1988

SNOWMOBILE INDEX - 1988

3. HINGED EXTENSION ADJUSTMENT: PAGE 2-38

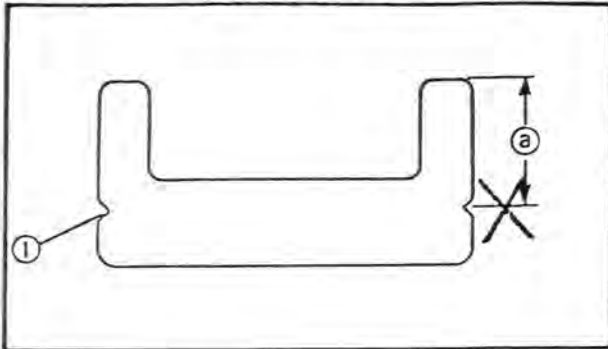
Correct: 2. Adjust:
 • Hinged extension

Reason: Misprint.

Extension adjustment step:		
• Turn the adjuster ① in or out until specified position.		
Snow Condition	Adjuster	Rigidity
Hard surface	Turn in	Stiffer
Loose snow	Turn out	Softer

4. SLIDE RUNNER INSPECTION: PAGE 2-41

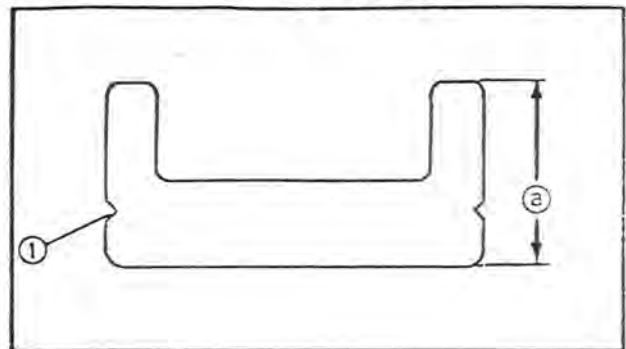
Correct: 2. Measure:
• Slide runner thickness
Out of specification - Replace.

Reason: Misprint.

5. SECONDARY SHEAVE (EXPLODED DIAGRAM): PAGE 5-10

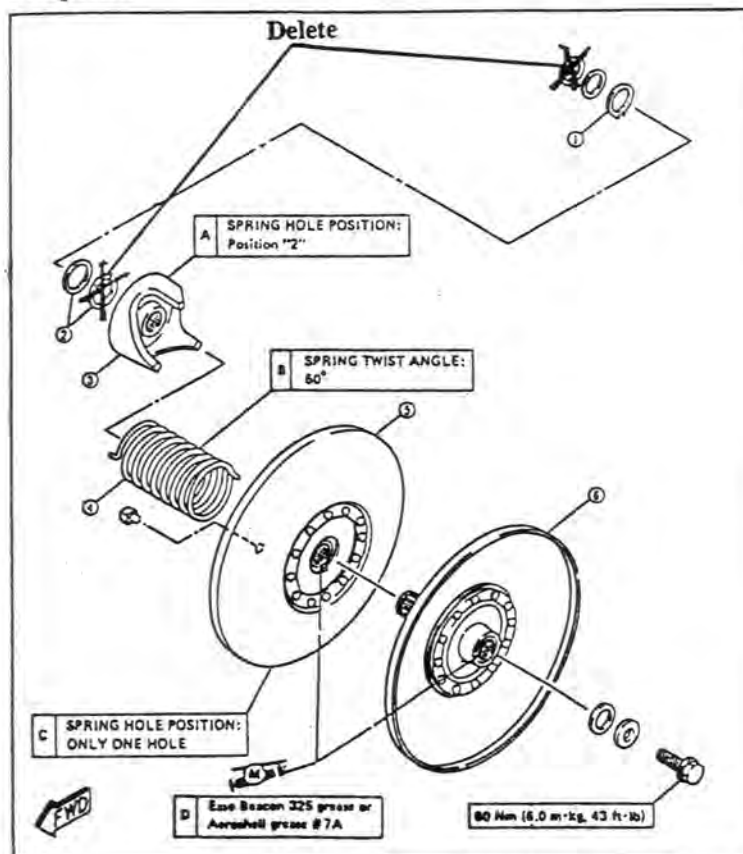
Delete: • Delete two shims as illustrated below.

Reason: Misprint.

SPECIFICATIONS

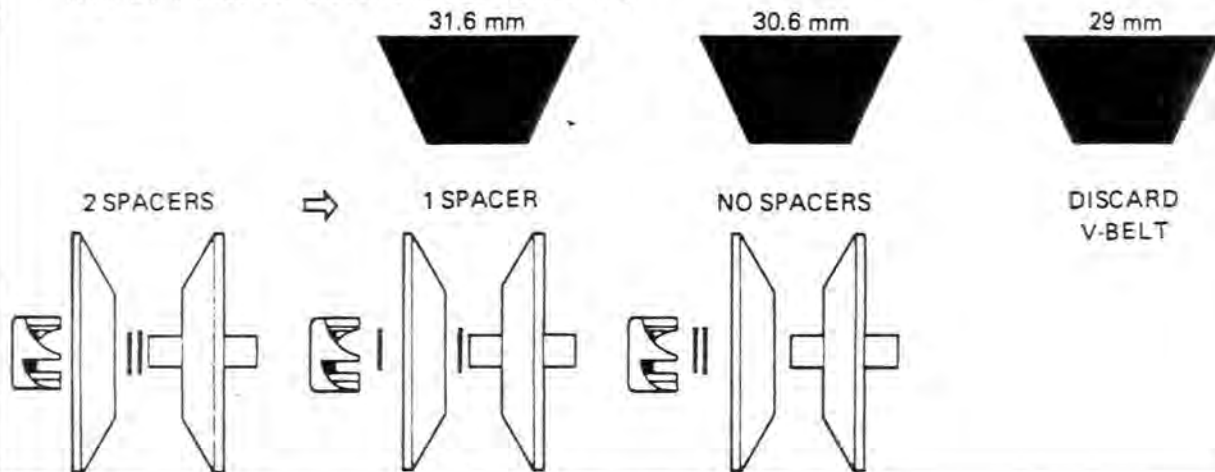
Secondary spring preload: 50° → 80° (A-3)

Secondary clutch shim: 2 pcs. → 1 pc.

NOTE: Please use clutch shim as illustration.

OIL TANK HEAT SHIELD BOLTS LOOSENING

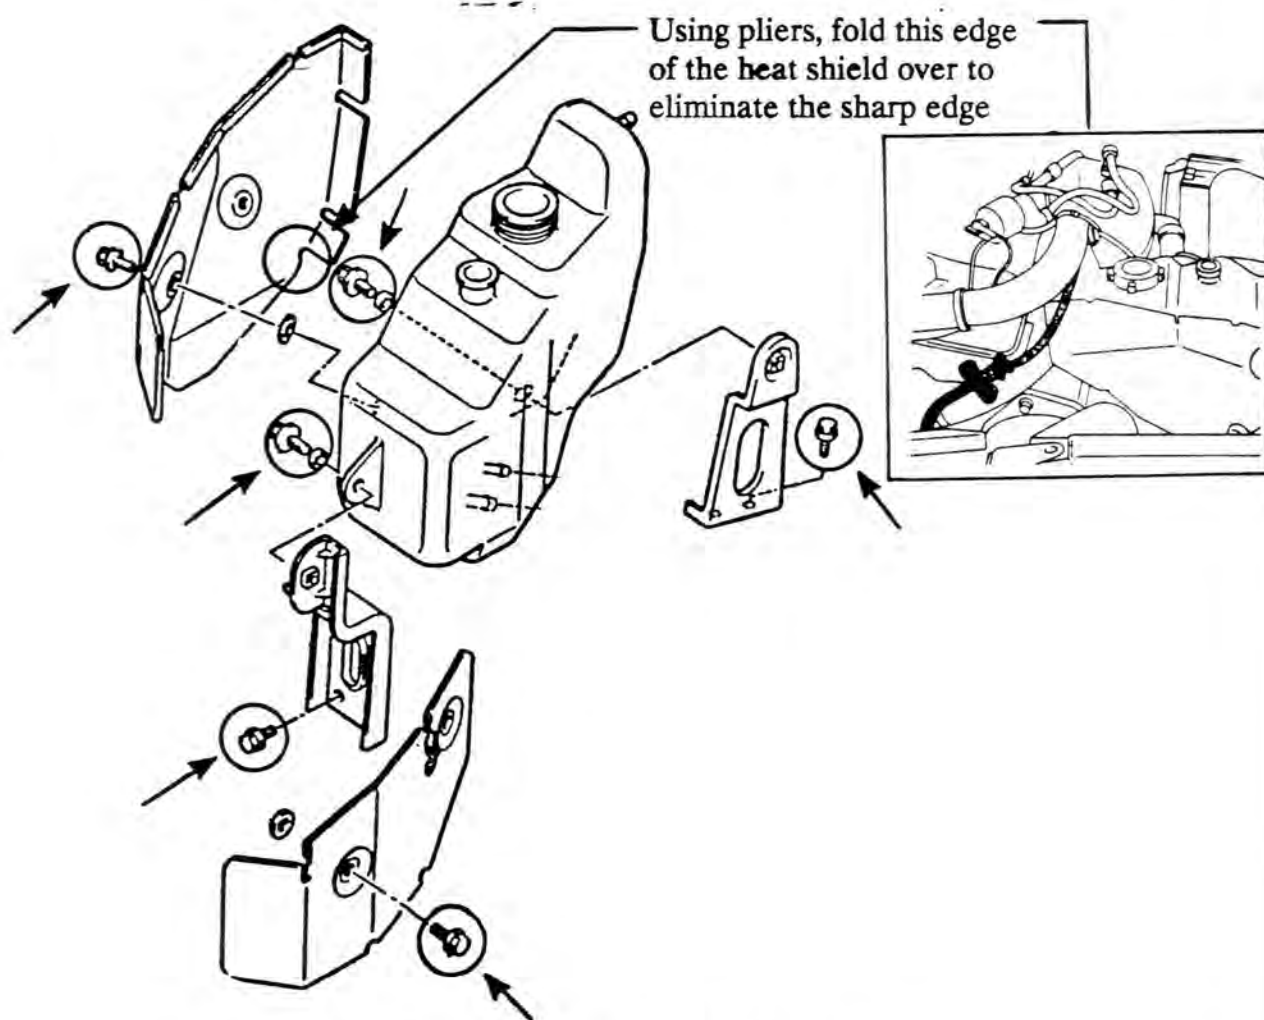
Field reports indicate that the heat shield bolts on the above models have been loosening due to vibration. In order to prevent this, we have decided to NEJI LOCK the oil tank bolts.

- Remove the four heat shield bolts and remove the heat shield. Bend the lower edge of the R.H. oil tank shield, as indicated in the illustration, to increase the clearance between the shield and lower coolant hose. This will prevent the hose from being cut.
- Remove the oil tank stay bolts, one at a time, apply NEJI LOCK (part number 90890-70043 or equivalent) to the threads and reinstall torque to spec. (6 Nm/0.6 m.kg/4.3 ft.lb)
- Apply NEJI LOCK (part number 90890-70043 or equivalent) to the threads of the heat shield bolts and reinstall.
- Check that the routing of the carburetor heat hose will not allow it to contact the notch in the oil tank heat shield.
- NOTE: There is a fibre washer installed between the oil tank and the heat shield.
- TORQUE TO SPEC. (6 Nm/0.6 m.kg/4.3 ft.lb)

S88-035

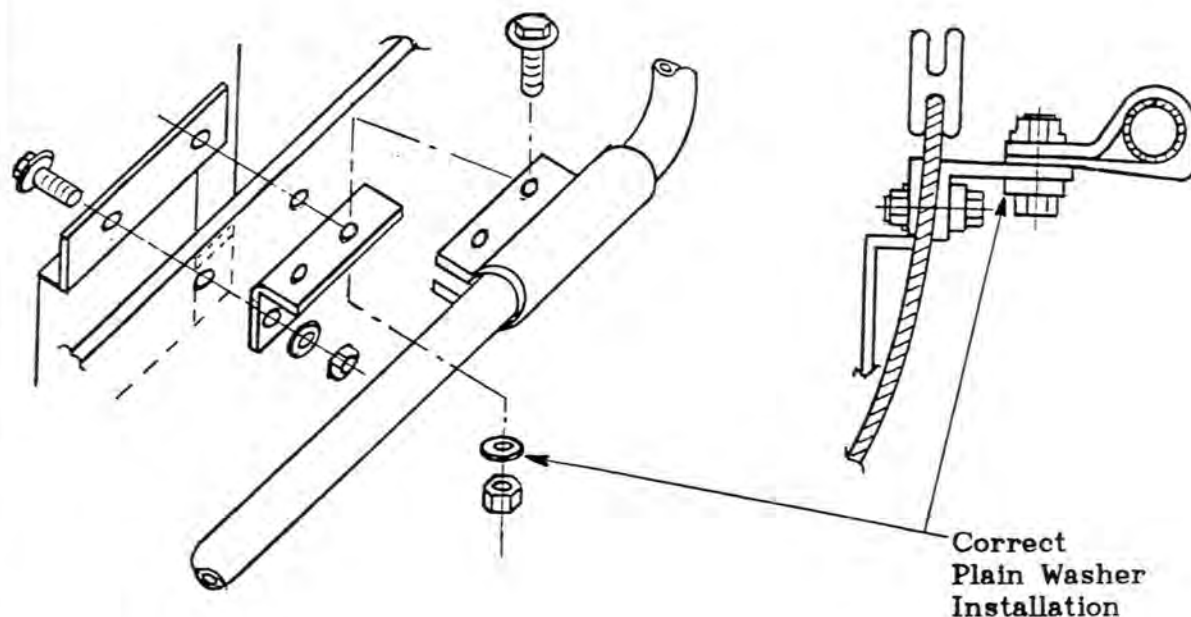
The factory has advised us that the wrong type of washer was put in the crate by mistake. A spring washer instead of the correct flat washer was packed.

When assembling the unit use the correct (plain) washer as shown in the illustration.

ASSEMBLY MANUAL CORRECTION

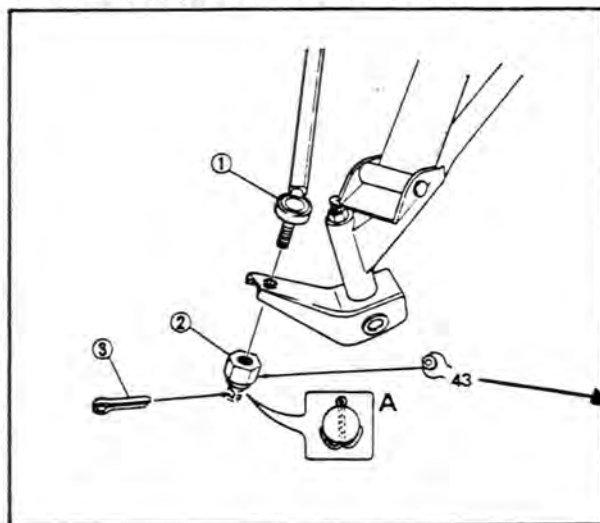
It has come to our attention that the torque specification given for the steering relay rod bolt was printed incorrectly in the Assembly Manual (part number 85G-28107-70-00). Please revise the information in your manual as per the information below.
